Airworthiness Directives; MD Helicopters, Inc. Model 369D, 369E, 369F, and 369FF Helicopters

ACTION: Notice of proposed rulemaking (NPRM).

MD Helicopters, Inc.: Docket No. 2001-SW-40-AD.

Figure 1 – Inspection Location

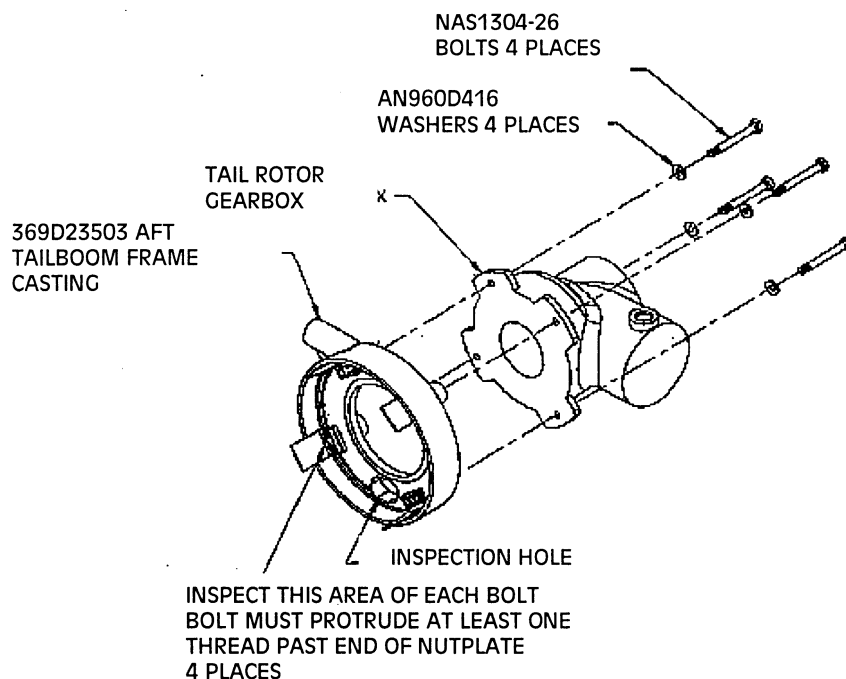
(2) Remove the tailboom control rod and determine the number of bolt threads protruding from each nutplate on the internal surface of the aft tailboom frame casting, P/

N 369D23503, as shown in Figure 1. At least one thread must protrude. If more than four threads protrude, add an additional washer, P/N AN960D416, under the bolt head. Torque the bolt to 100–110 in-lbs., and reapply a slippage mark.
